FINDING OF NO SIGNIFICANT IMPACT

**Deerfield Road (CH 11, FAU 1257) - US 45/IL 21 (Milwaukee Avenue) to
Saunders/Riverwoods Road, Lake County, Illinois**

ERRATA

FIGURE C-2:
 ENVIRONMENTAL RESOURCES MAP
 SHEET 4

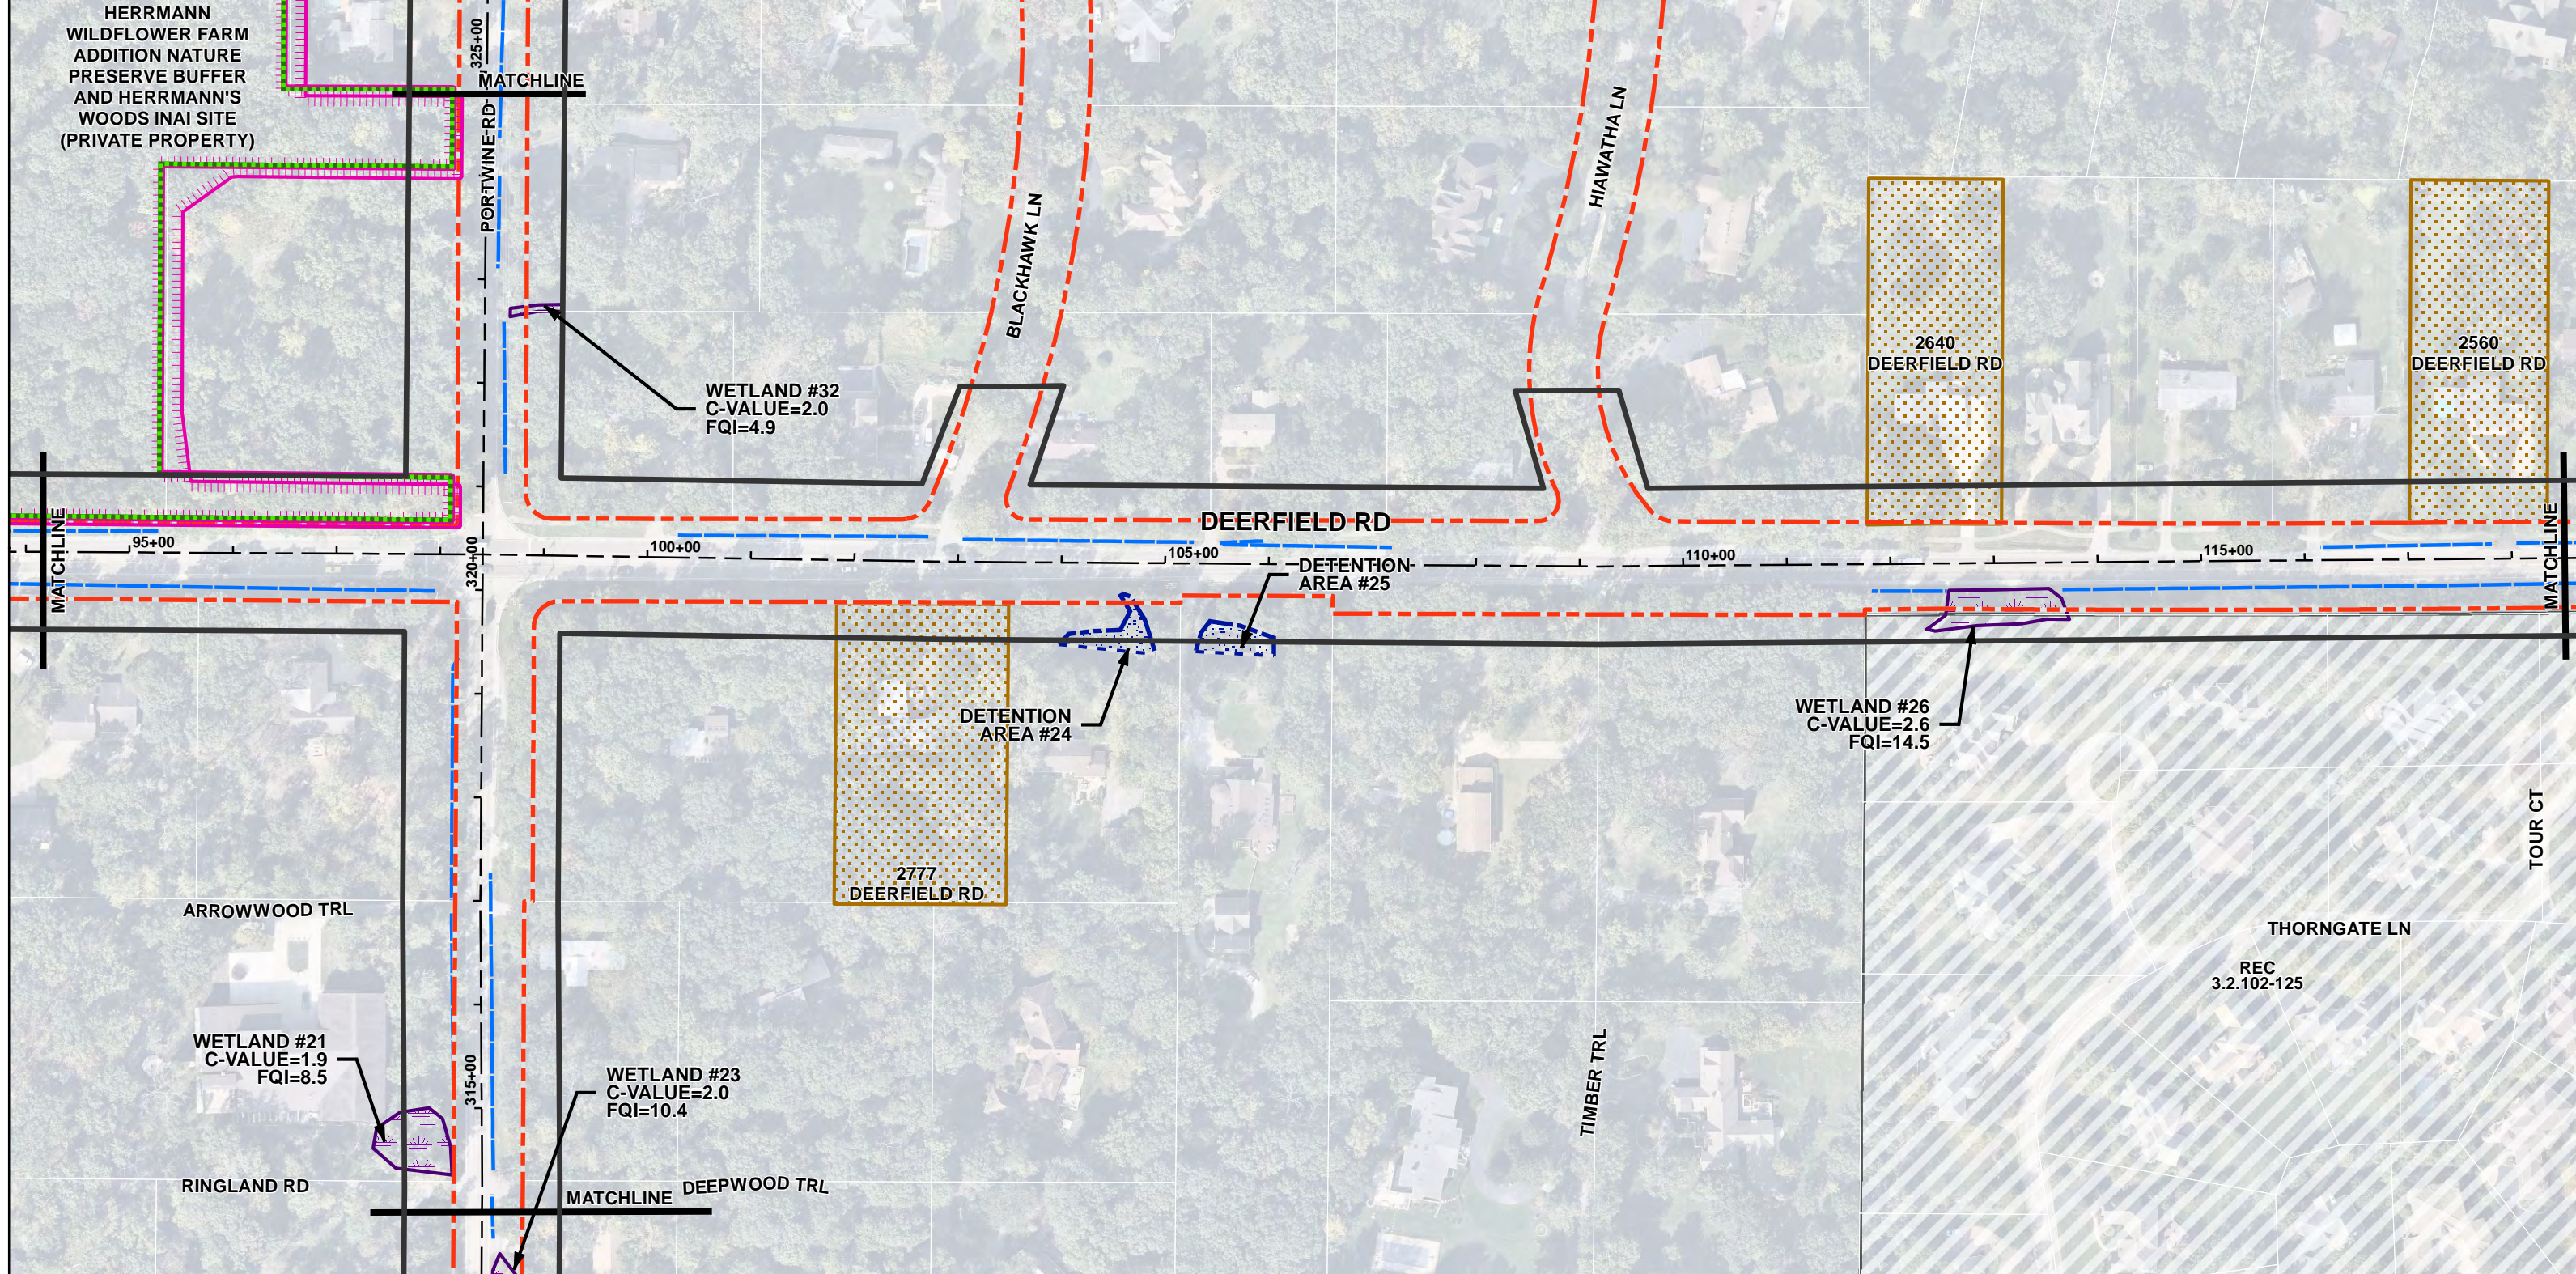
Appendix C, Figure C-2: Environmental Resources Map, All Sheets, Replace all sheets with the revised exhibits shown below to correct for a display error (INAI boundary) on Sheets 4, 5 & 10 for consistency with the EA text and agency coordination. In order to update the exhibits, the IDNR data license was renewed, and the legend was updated with a revised “source date” on all sheets. A new REC was added on Sheet 6 (3.2.99 Ray’s Auto) based on the PESA update.
